Pole Star Fashion & Design Ltd.

Sharifpur, National University, Gazipur, Bangladesh
(23.96554N, 90.36843E)

06 April 2014

Structural plans do not align with as-built layouts

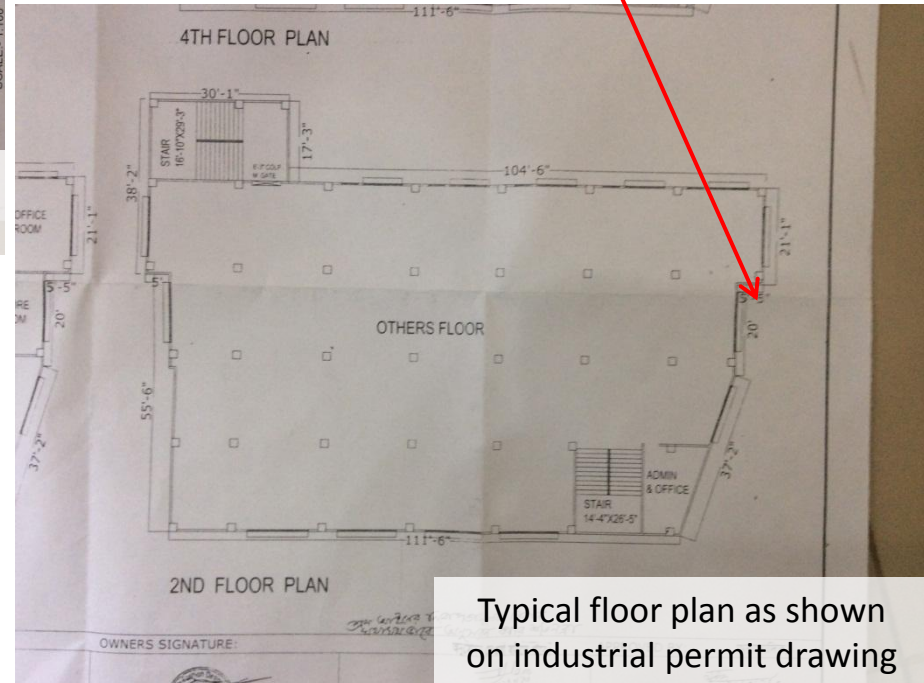
Structural layout drawings do not match as-built layout or industrial permit drawings.

Building cantilevers beyond column line at first floor and above. As-built drawings to be created to suit

Engineer to produce as-built drawings that are consistent with building frame.

Edge beam eccentricity

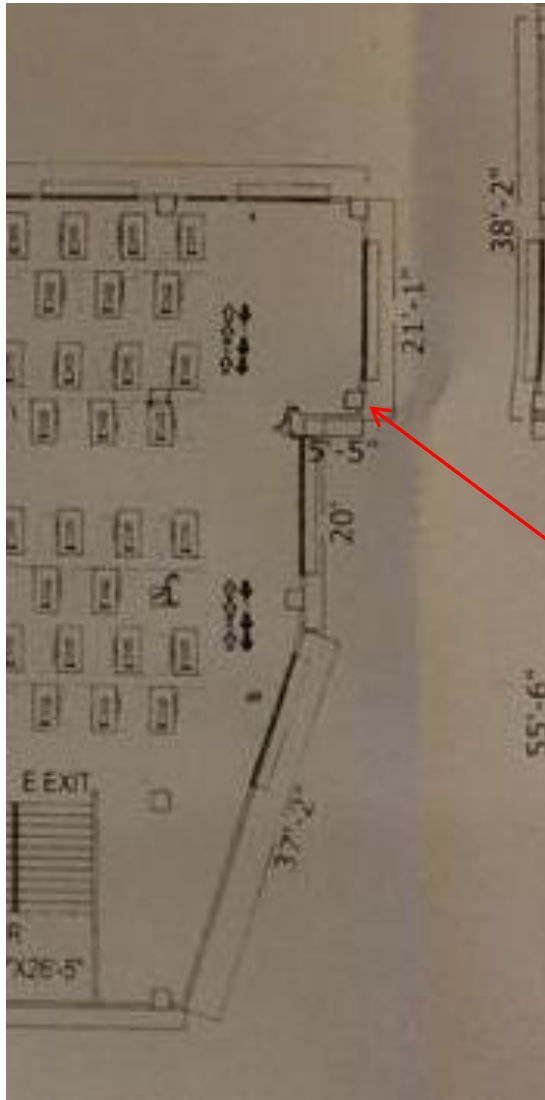
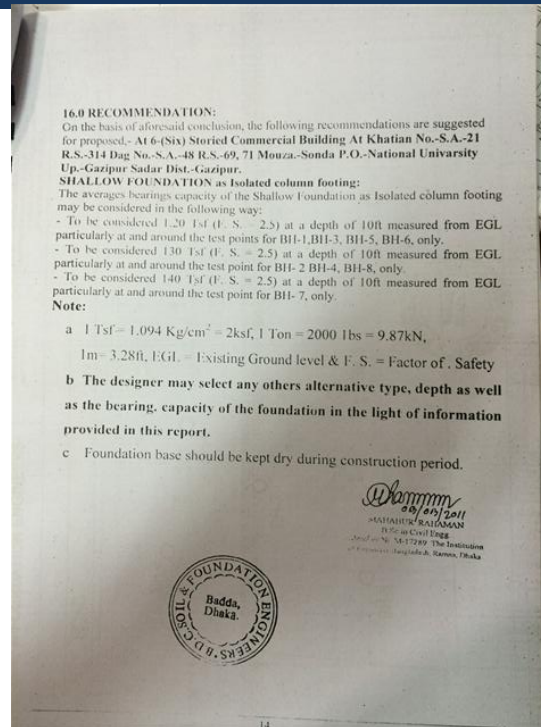
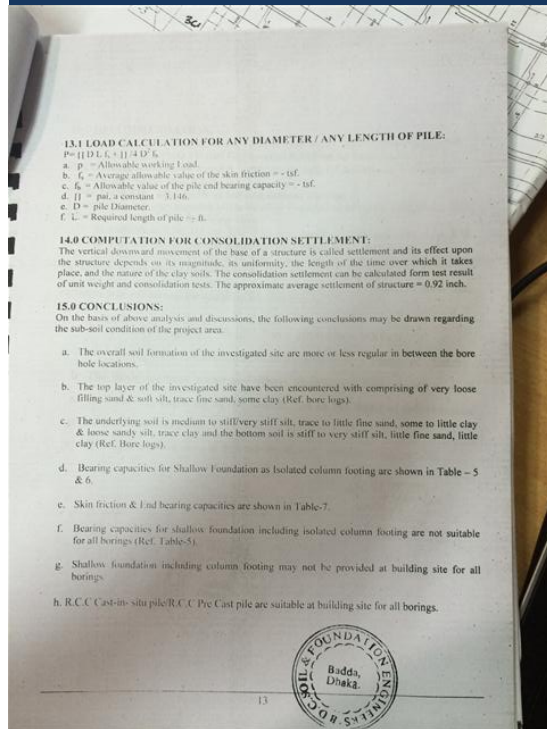
Building plans do not correspond with as-built structural framing.

Beams and columns shown to line through on drawings but are offset in reality. Engineer to confirm that beam has been designed and detailed for torsion and that column is designed for beam eccentricity.

Level differences around site

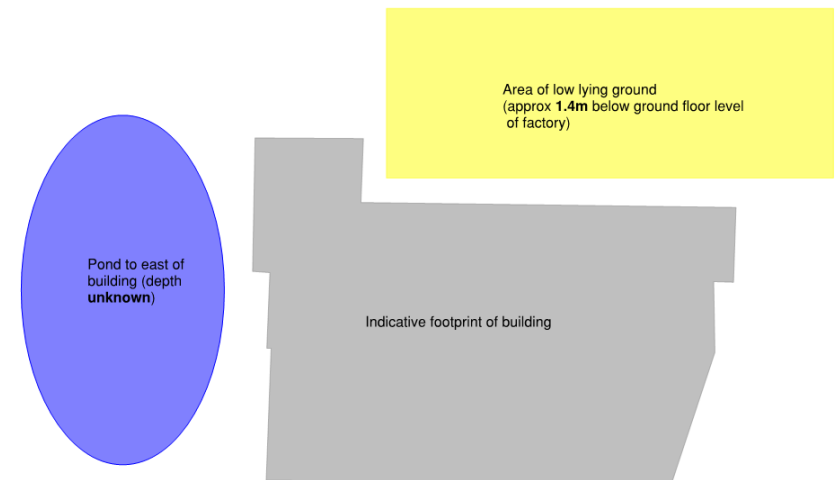
Around the building perimeter there are areas of lower ground e.g. in front of retaining wall and ponds close to building perimeter. These are not mentioned in the soils report. Engineer to confirm that these excavations and proximity to pond do not affect the building foundations. Suggest trial pits are dug to confirm foundation level.

Retaining wall adjacent to building perimeter

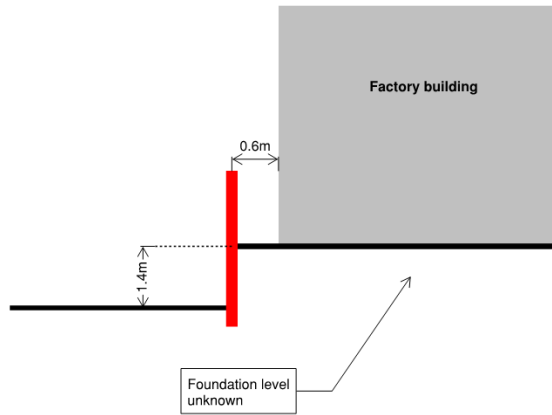
No drawings available for single skin masonry wall along northern extent of building (approximate 0.6m from building perimeter). Wall is retaining approximately 1.4m earth on the building side.

Masonry wall appears to have deflected significantly but no movement evident in building façade or structure. Bamboo props appear to have been installed.

Engineer to confirm that foundation level of building is below retained soil and that building does not surcharge wall.

Concrete water tank planned for roof

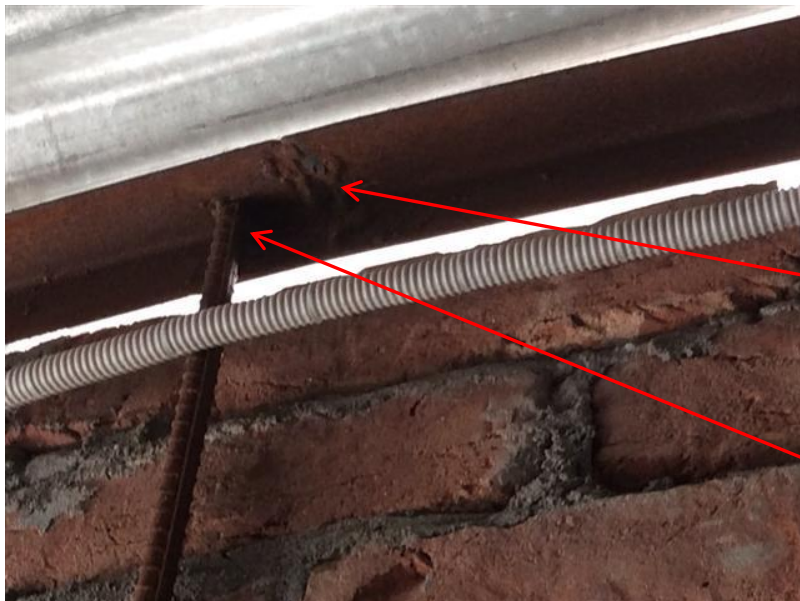
The building manager confirmed that a reinforced concrete water tank is to be placed on the roof once construction is complete. The location of this water tank is unclear. **It must not be built until the Detail Engineering Assessment is complete.**

The engineer is to check that the structure is capable of supporting the applied loading from the water tank.
